| FOREST LAKES FILING NO. 5, 6 & 7 GRADING INDEX REFERENCE SHEET | | | |
| PRE-DEVELOPMENT GRADING AND EROSION CONTROL PLAN | | | |

| FOREST LAKES FILING NO. 5, 6 & 7 | | | |
|--|--------------|--------------|---------------|
| PRE-DEVELOPMENT GRADING AND EROSION CONTROL PLAN | | | |

| FOREST LAKES FILING NO. 5, 6 & 7 | | | |
|--|--------------|--------------|---------------|
| DRAWN BY | BB | (H) 1" = 50' | SHEET 3 OF 13 |

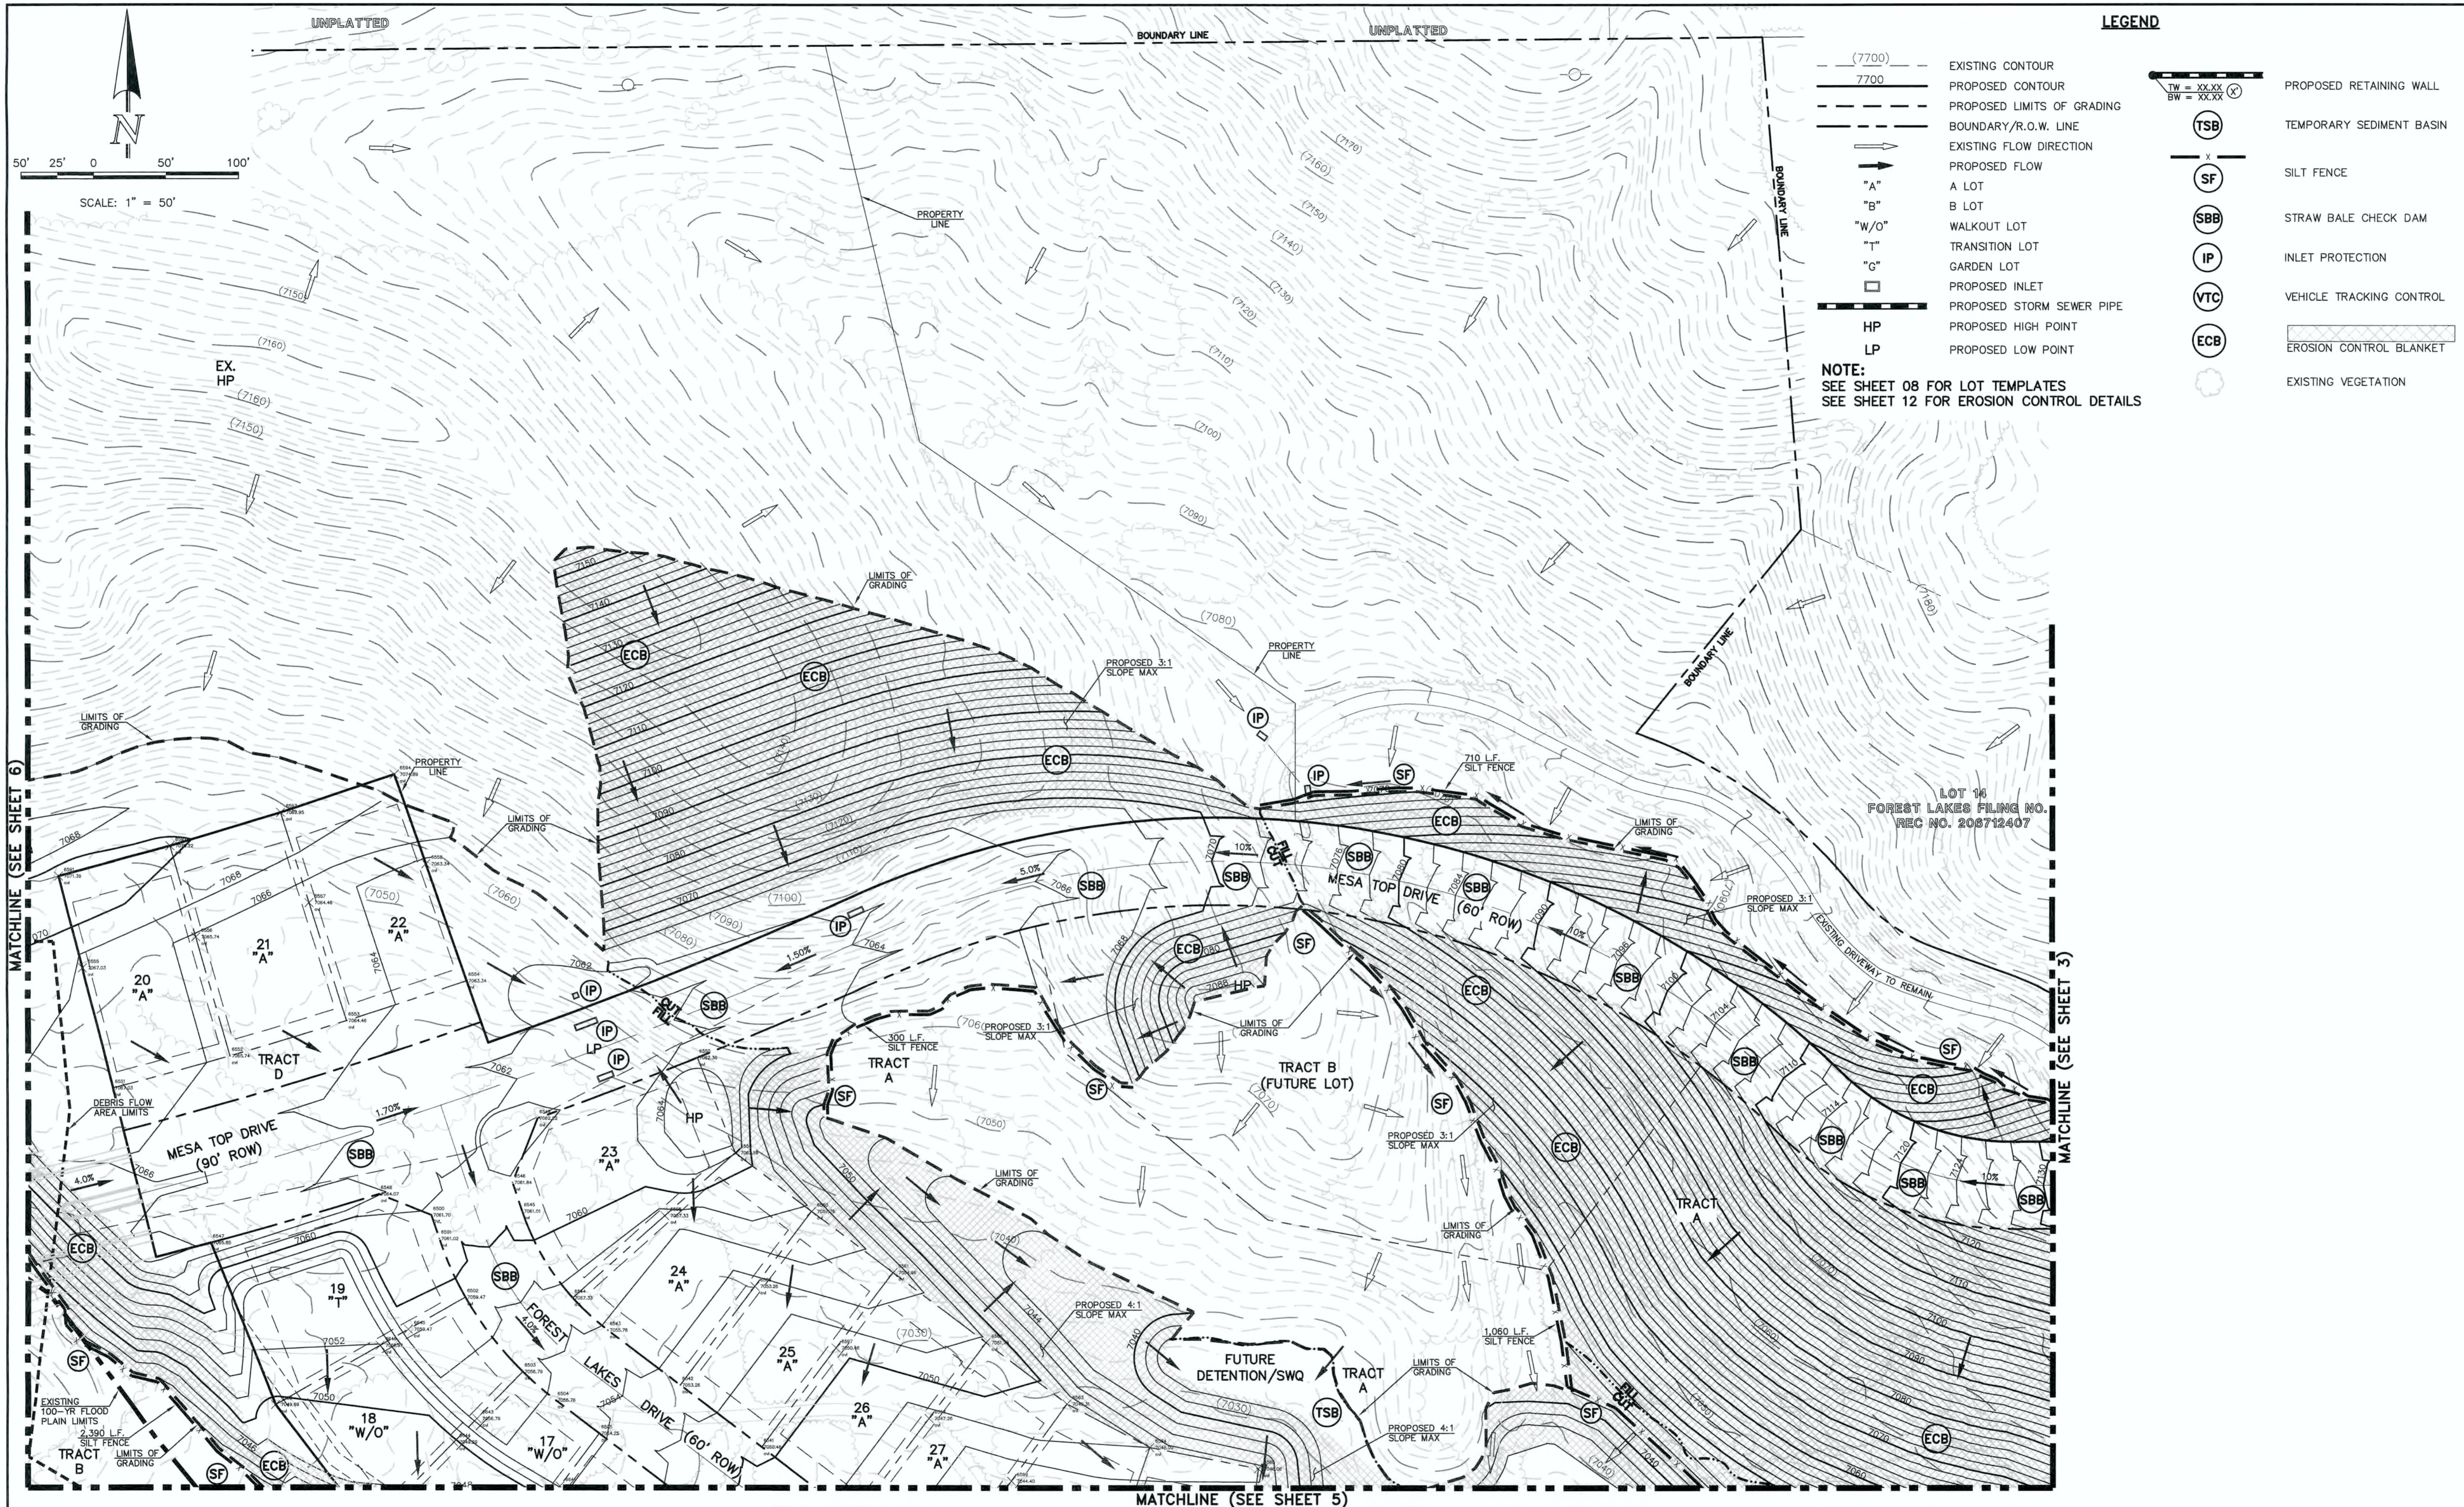
Contours shown appears to be finished grade elevation, not subgrade for early grading. Either modify to show subgrade contours or provide a typical cross section detail noting the subgrade grading associated with this plan relative to the finished grade shown on the plans. Example of what another application provided. Unresolved.

Contours shown appears to be finished grade elevation, not subgrade for early grading. Either modify to show subgrade contours or provide a typical cross section detail noting the subgrade grading associated with this plan relative to the finished grade shown on the plans. Example of what another application provided. Unresolved.

| DRAWN BY | BB | (H) 1" = 50' | SHEET | 5 OF 13 |

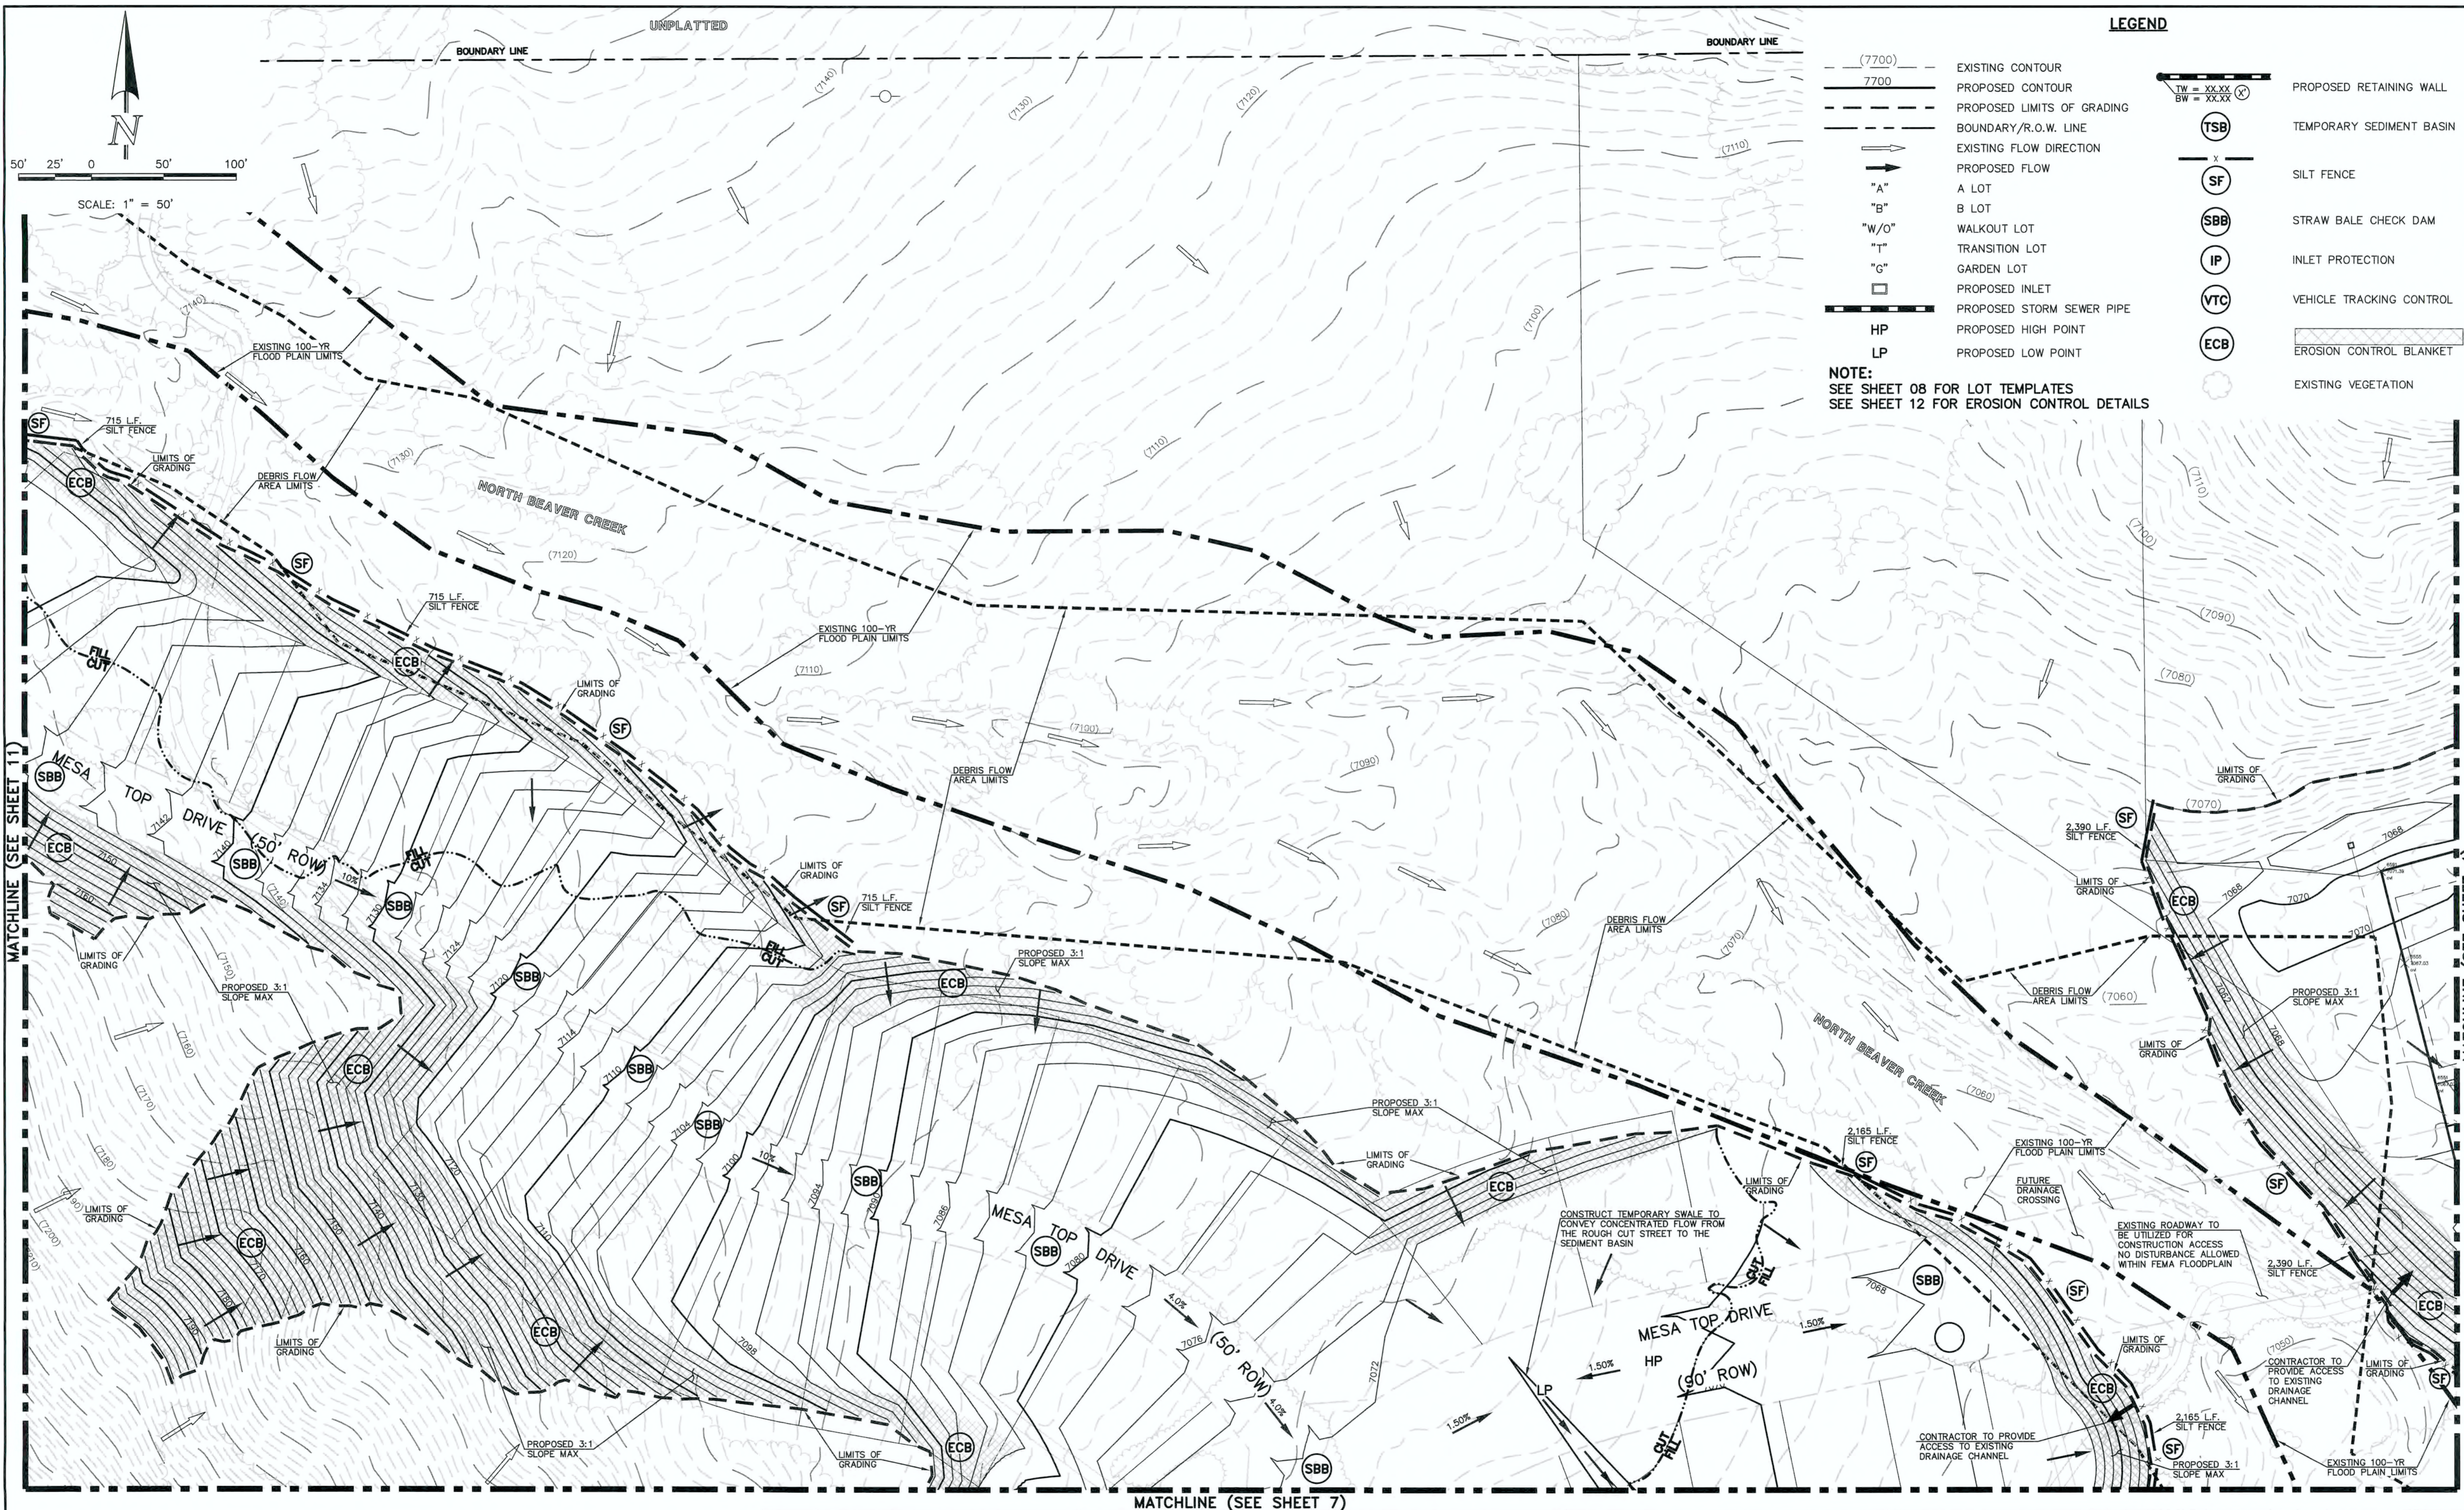
Remove inlet protections for proposed inlets and replace with temporary swales to direct flows into the temporary sediment basins.

Temporary BMP shown downstream of the LP does not appear sufficient. Additional BMPs is required or provide temporary swales to convey runoff from the lowpoint to the temporary sediment basin.

Unresolved. a Temp Sediment Basin is shown on the resubmittal however temporary swales are not provided to direct runoff to the TSB. Silt fence along the perimeter still exceeds the maximum drainage area of 1/4 acre per 100 feet of silt fence length.
